## DEVELOPMENT APPLICATION ASSESSMENT REPORT

<b>Application Number:</b>	DA2021/0329
----------------------------	-------------

<b>Responsible Officer:</b>	Kent Bull
<b>Land to be developed (Address):</b>	Lot 53 DP 22275, 49 Binburra Avenue AVALON BEACH NSW 2107
<b>Proposed Development:</b>	Alterations and additions to a dwelling house including swimming pool and driveway
<b>Zoning:</b>	E4 Environmental Living
<b>Development Permissible:</b>	Yes
<b>Existing Use Rights:</b>	No
<b>Consent Authority:</b>	Northern Beaches Council
<b>Land and Environment Court Action:</b>	No
<b>Owner:</b>	William Leslie Kiloh
<b>Applicant:</b>	THW Architects

Figure 1: Annotated site plan marking a 6.5m front building line in red.

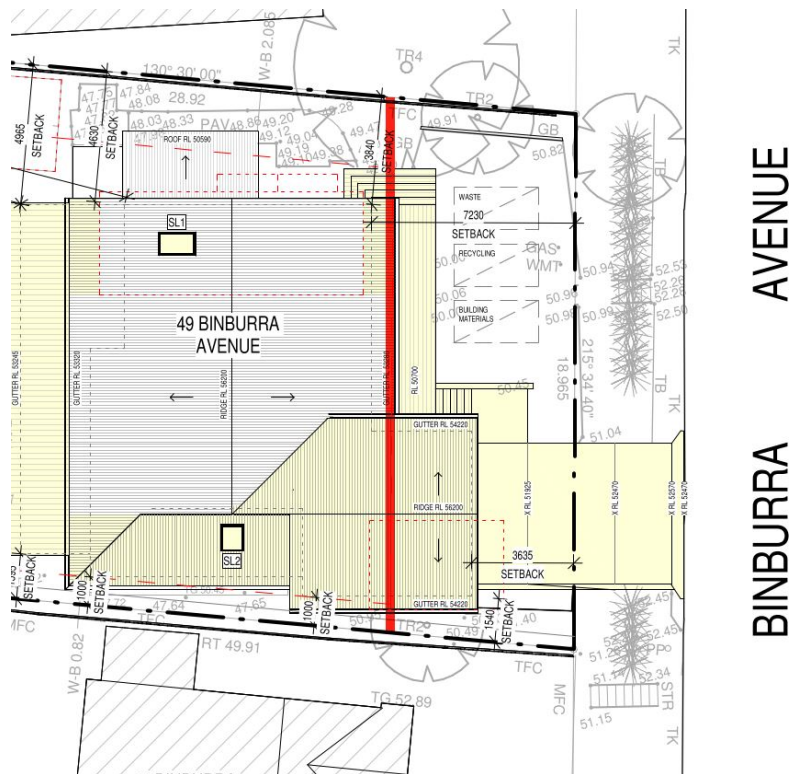
The proposed garage is non-compliant with the 6.5m front building line requirement, being 3.6m from

the eastern boundary to Binburra Avenue.

NB: Excluding the garage, the dwelling house is compliant with the front building line, being 7.18m from the eastern boundary. It should also be noted that the carport (recently demolished) had previously been located within the front setback area and nearer to the eastern boundary.

Based on the above, the proposed development is considered acceptable in merit and consistent with the Outcomes of this clause in this particular instance.

Figure 2: Extent of the building envelope breach along the southern elevation shaded red.

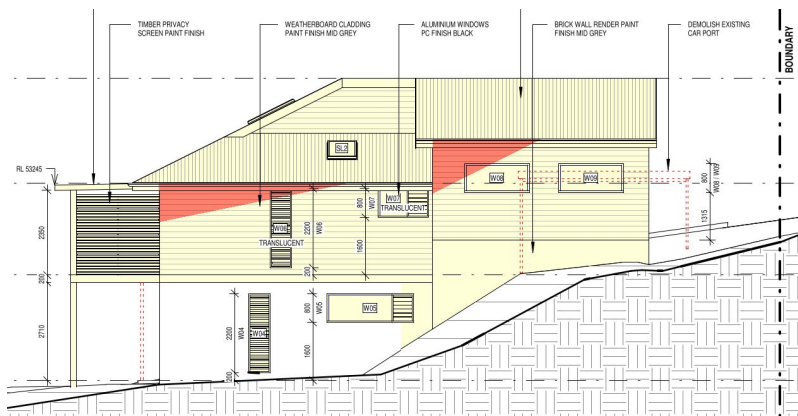
The proposed development results in a breach to the building envelope along southern elevation by 1.469m. The greatest extent of the breach relates to the garage addition as depicted in Figure 2.

In accordance with this clause, Council may consider a variation for additions of a second storey where the existing dwelling is retained. This variation is largely applicable given the the ground floor is being retained and the breaches relate to the first floor level (street floor plan). The variations sought for the proposed development does not result in an unreasonable impact to neighbouring properties with regards to views, privacy and solar access. Furthermore, the proposal is consistent with achieving the desired future character of the locality and visual impacts on the streetscape through limiting the built form of the proposed development and enhancing the site through the provision of native canopy trees and screening/shrub plantings within the setback areas.

Based on the above, the variations to the control are supported on merit in this instance, as the proposed development is considered to satisfy the Outcomes of this clause.
